ADDENDUM NO. 2 TO THE PROJECT MANUAL

NEW RIVER CHANNEL IMPROVEMENTS
ASCENSION PARISH, LOUISIANA

PARISH PROJECT NO. EAD 15-004
HDCA PROJECT 2017-14

H. Davis Cole &
Associates, LLC
Consulting Engineers

D1. Sheet G2, Earthwork, Note 4, **DELETE** in its entirety and **REPLACE** with the following:

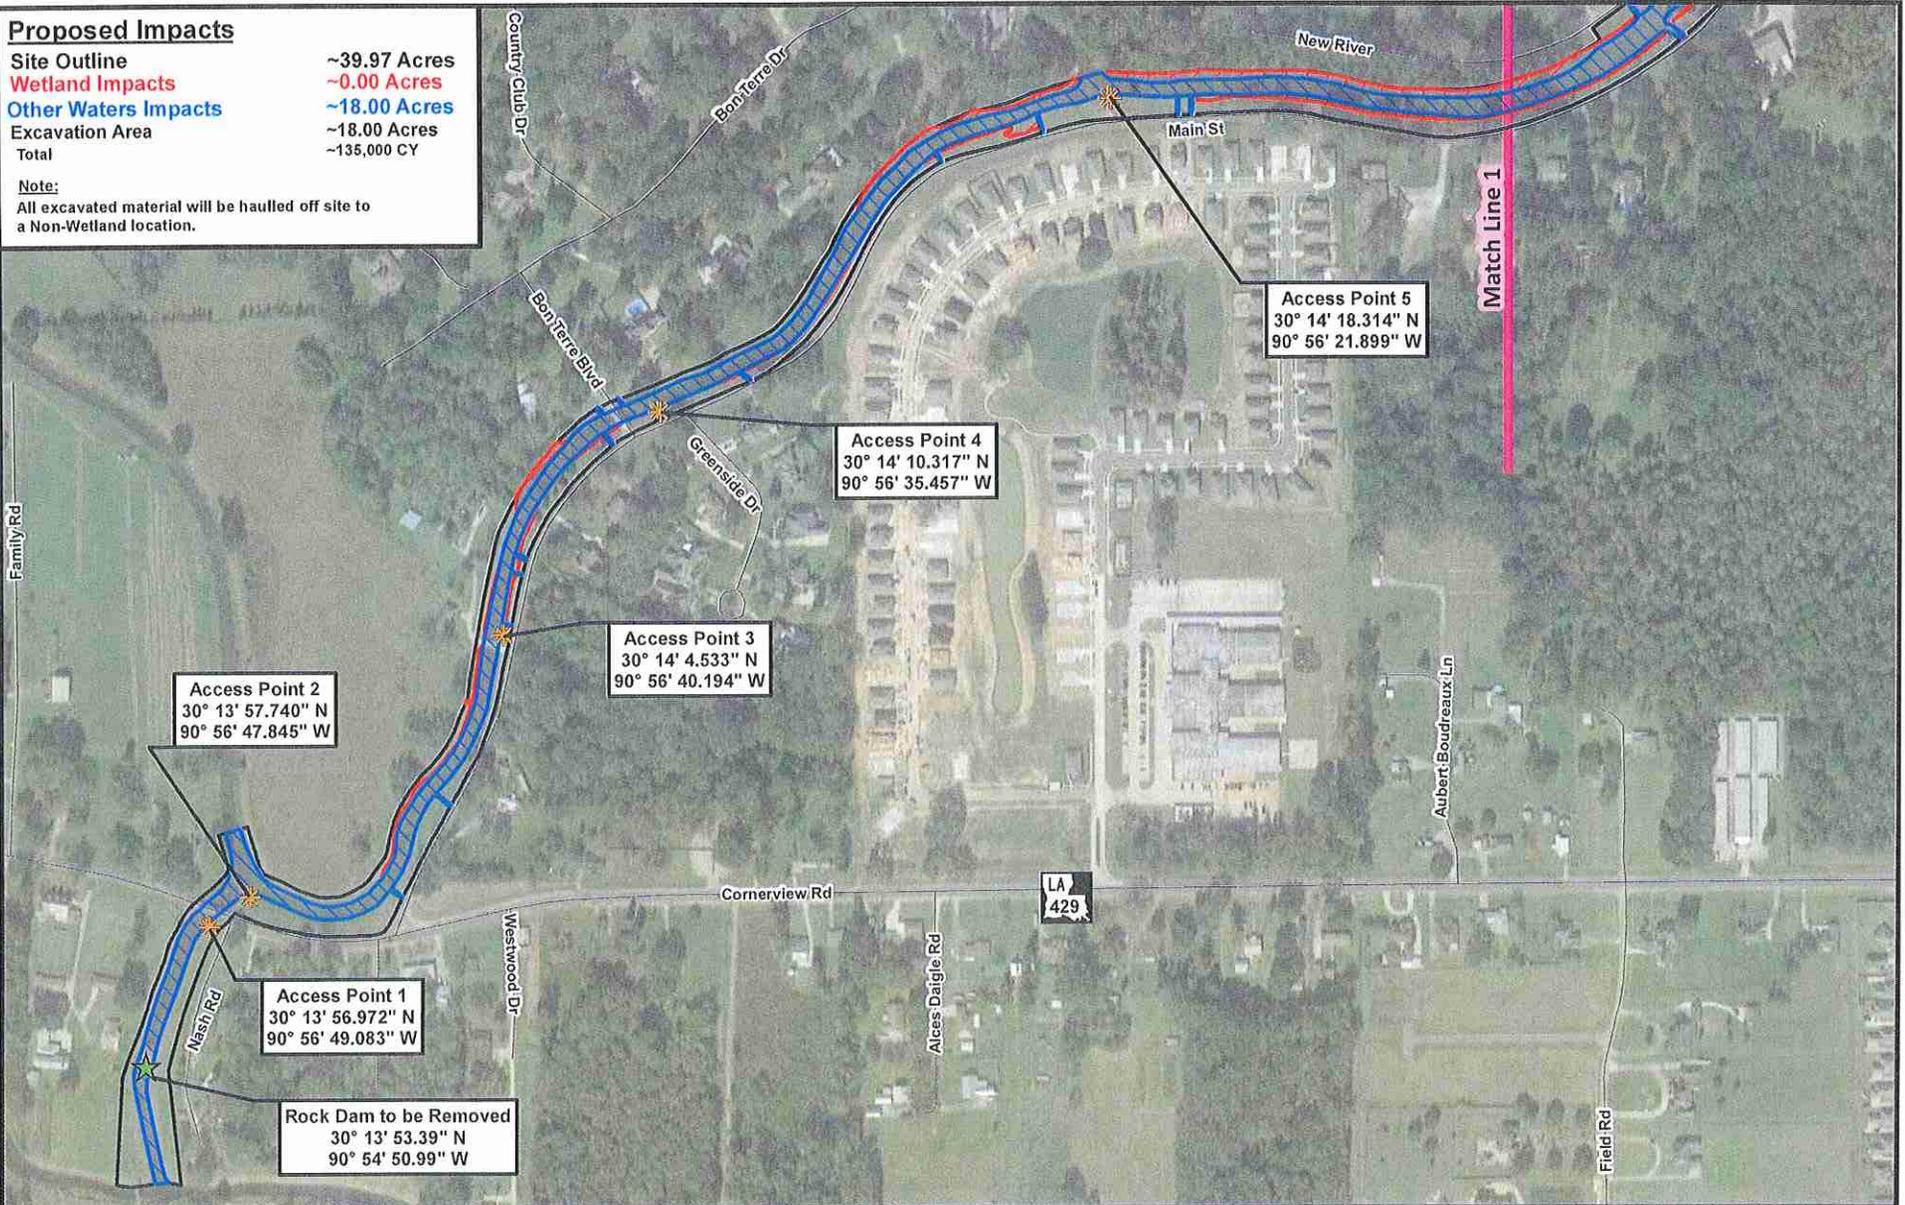
4) The contractor shall remove and exclude water, including stormwater, groundwater, irrigation water, and wastewater, from excavations. Dewatering wells, well-points, sump pumps, or other means shall be used to remove water and continuously maintain groundwater **at a level corresponding to the bottom of excavations** before the excavation work begins at each location. Water shall be

removed and excluded until backfilling is complete and field soils testing has been completed. **“Each location” refers to the area between each set of dewatering dams. The contractor is responsible for maintaining the groundwater within each set of dewatering dams as they are removed and relocated along the channel in accordance with the construction schedule.**

Figure 2.2: Plan View

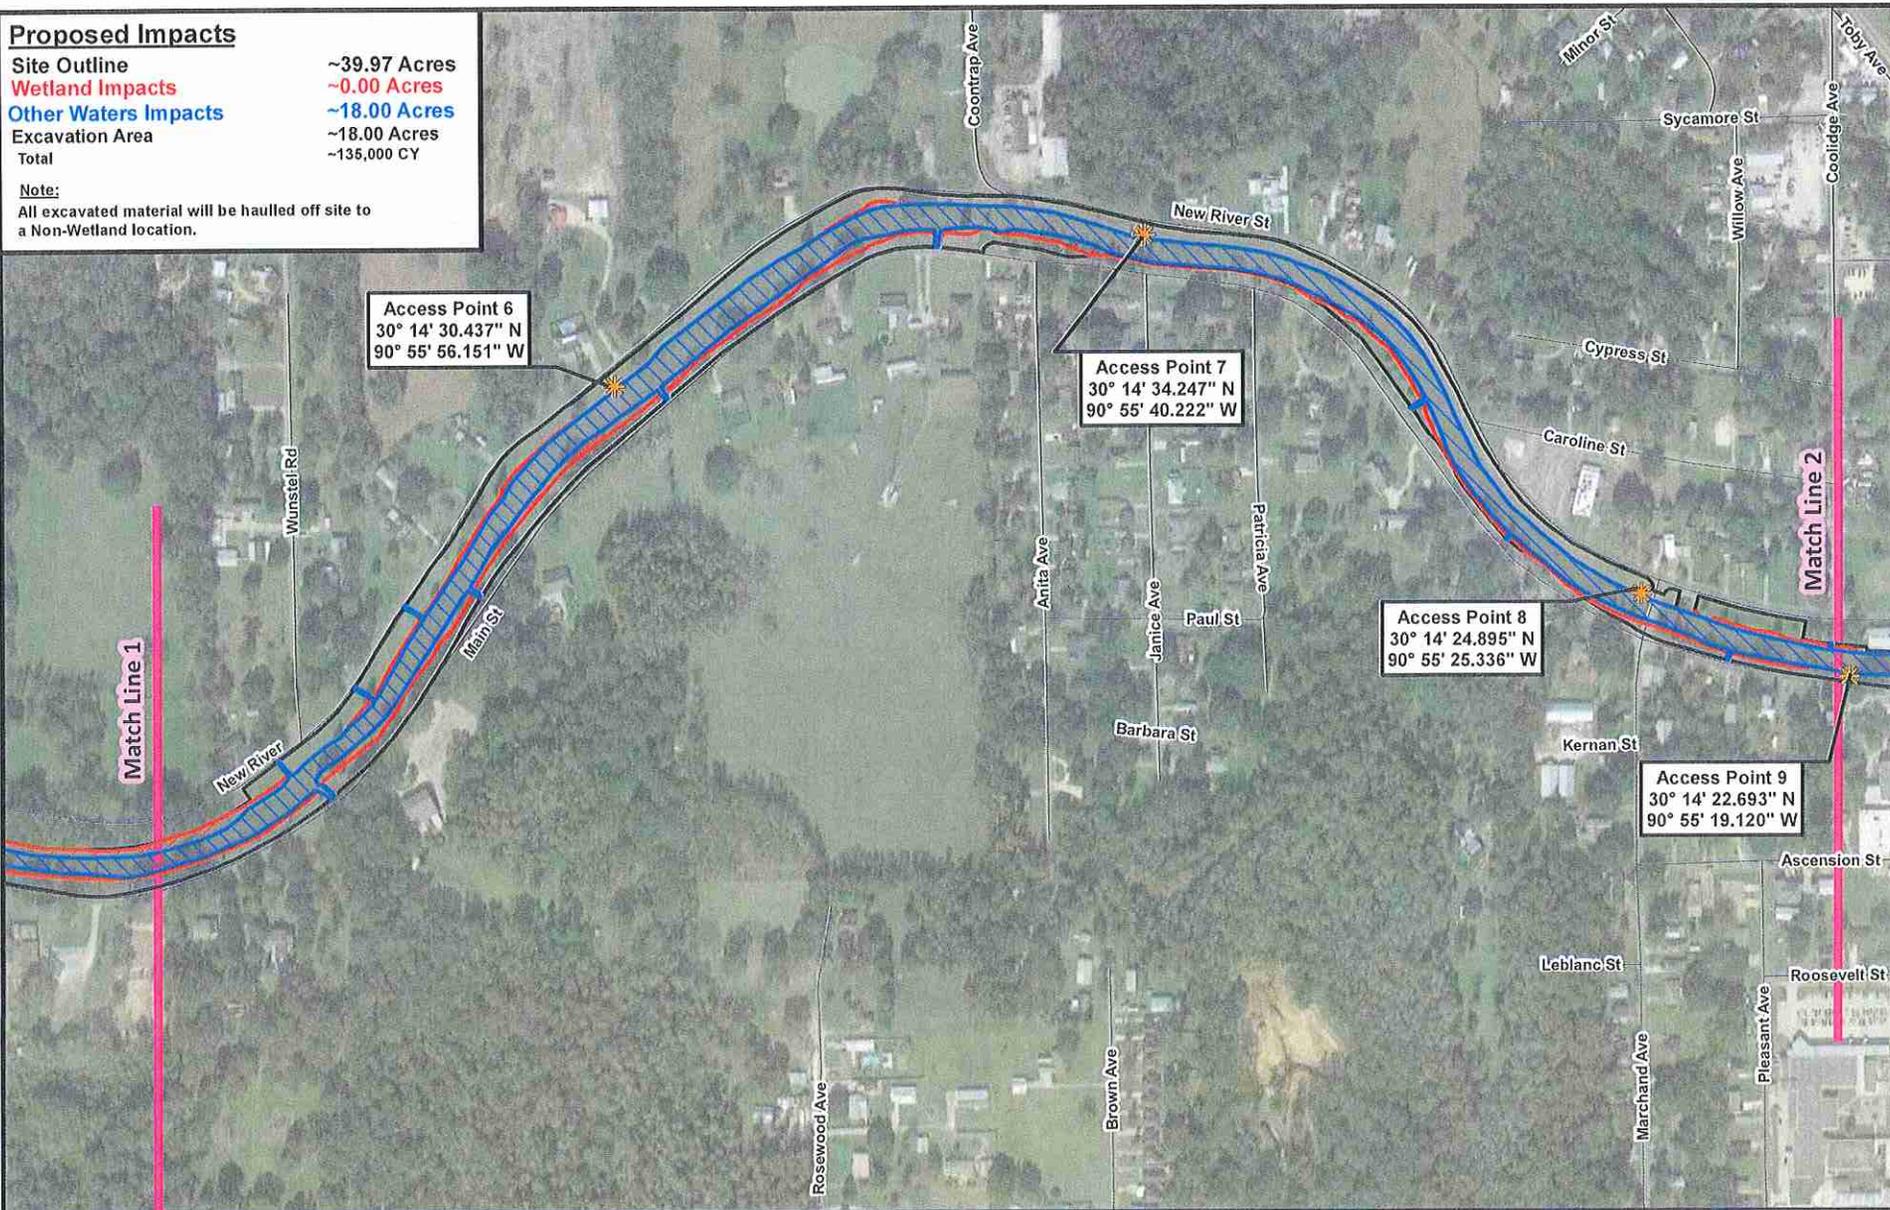
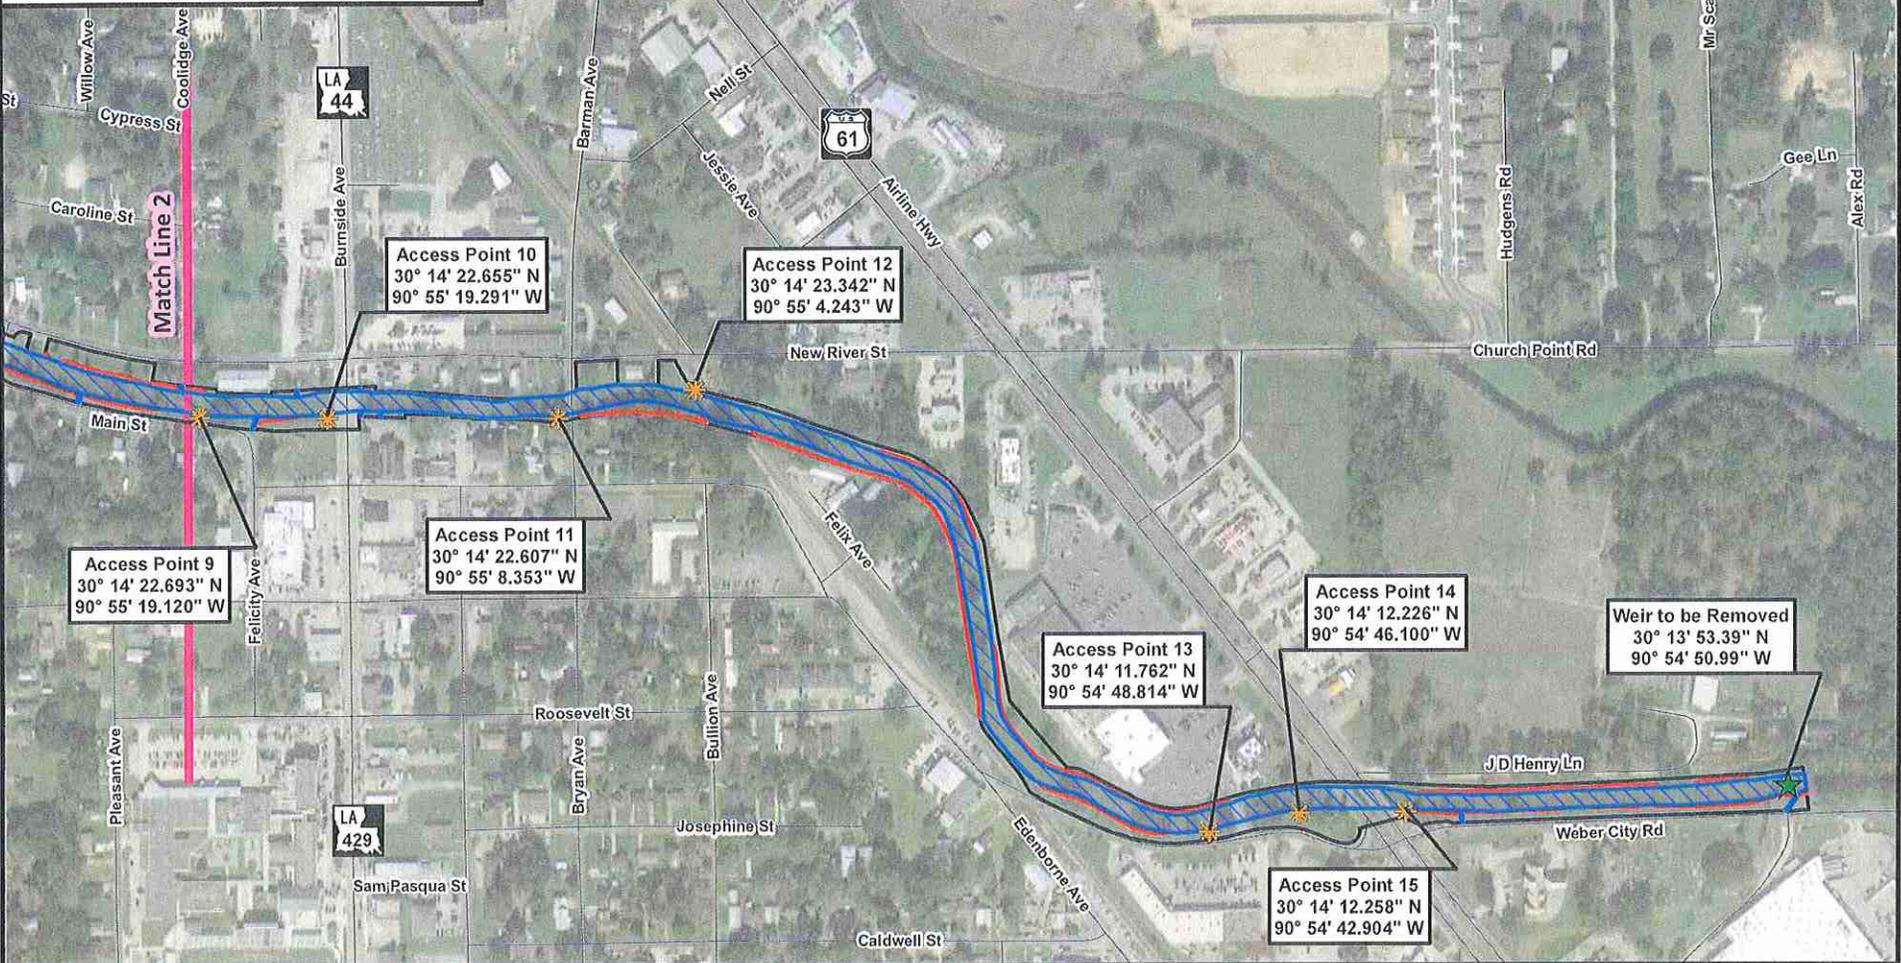
- A1. Pre-Bid Conference Sign-In Sheet
- A2. Wetland Permit Package – Access Points
 - a. Disregard reference to the Rock Dam to be removed (Sheet 1/3) and Access Point 1 (Sheet 1/3), both are outside of project limits. The first access point to be considered shall be Access Point 2.
- A3. Revised Bid Form
- A4. Revised Specification Section 01025 – Measurement and Payment
- A5. Revised Drawings Sheet G8

- C5. **Question:** *How many access points to the channel can be provided for the WORK?* **Answer:** See attachment entitled Wetland Permit Package that shows the appropriate access points to the channel. Each access point area varies however no access point shall have a width greater than 40 feet.

TIMBER PILE BULKHEAD DETAIL
SCALE: VARIES (8.5" x 11" SHEET)

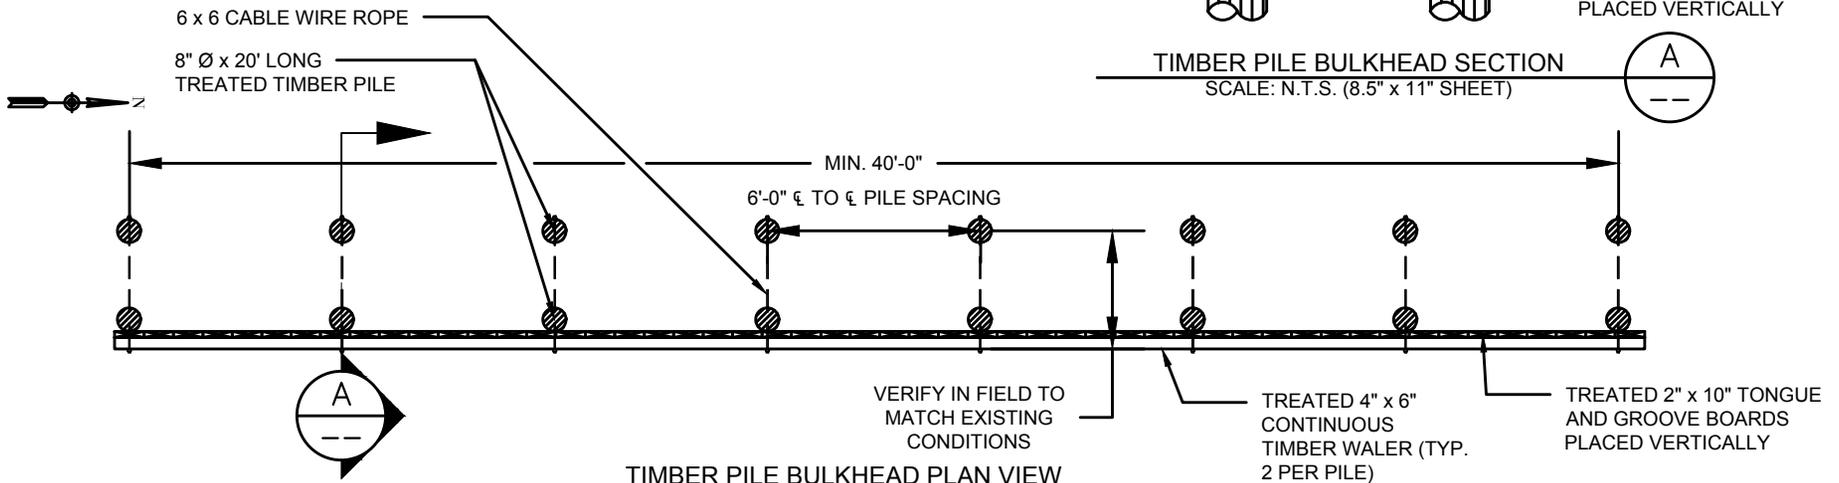
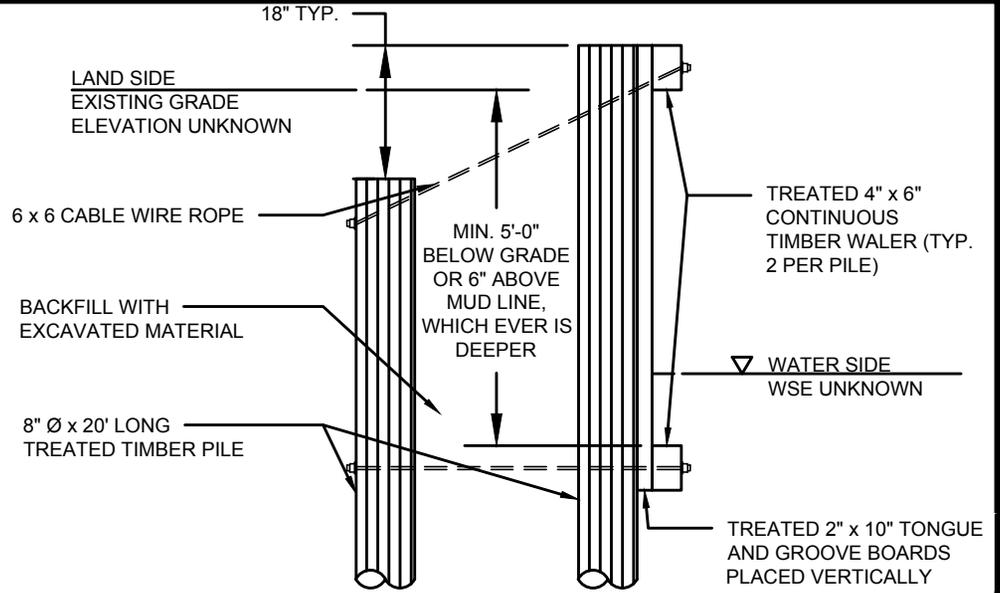
- A6. Timber Pile Bulkhead Detail
- A7. Specification Section 02804 – Driven Piles
